DEVELOPMENT APPLICATION ASSESSMENT REPORT

Application Number:	DA2022/0032
----------------------------	-------------

Responsible Officer:	Megan Surtees
Land to be developed (Address):	Lot 17 DP 19657, 6 Stephen Street BEACON HILL NSW 2100
Proposed Development:	Alterations and additions to a dwelling house
Zoning:	Warringah LEP2011 - Land zoned R2 Low Density Residential
Development Permissible:	Yes
Existing Use Rights:	No
Consent Authority:	Northern Beaches Council
Land and Environment Court Action:	No
Owner:	Craig Anthony Willi Haack Leanna Stanley
Applicant:	Craig Anthony Willi Haack Leanna Stanley

Image 1. East elevation building envelope breach.

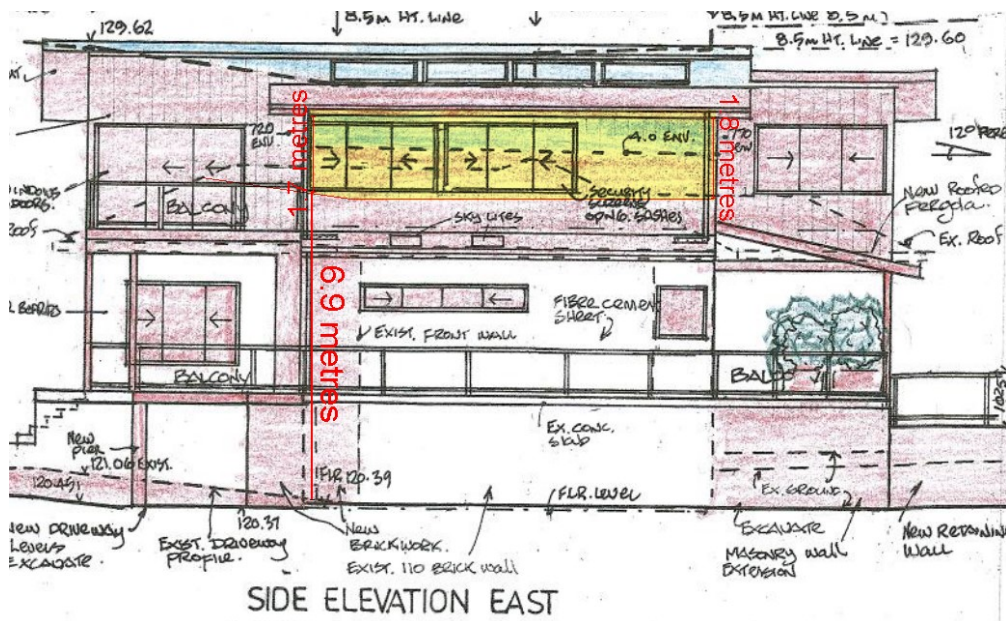
The proposed development extends beyond the building envelope along both the eastern and western elevations (as identified in the images below - breach shown in yellow).

The breach to the eastern elevation is sited only to a portion (about 50%) of the proposed first

floor addition. And the breach to the western elevation is for the entire length of the proposed first floor addition (approximately 16.0m.) However, the breach to the western elevation is not as severe (770mm) as the breach to the eastern elevation (1.8m, max.), which is due to the sloped nature of the site along the eastern boundary and the retention of the existing eastern side setback distance.

In this instance, and in conjunction with the proposed spatial separation between buildings (particularly to the dwelling at 8 Stephen Street), the non-compliance to this control is considered acceptable and is unlikely to give rise to visually bulky dwelling house.

Notwithstanding the numerical non-compliance to this control, the proposed development, as indicated in the above merit consideration, can achieve the underlying objectives of this control. As such, the variation can be supported on its merits.
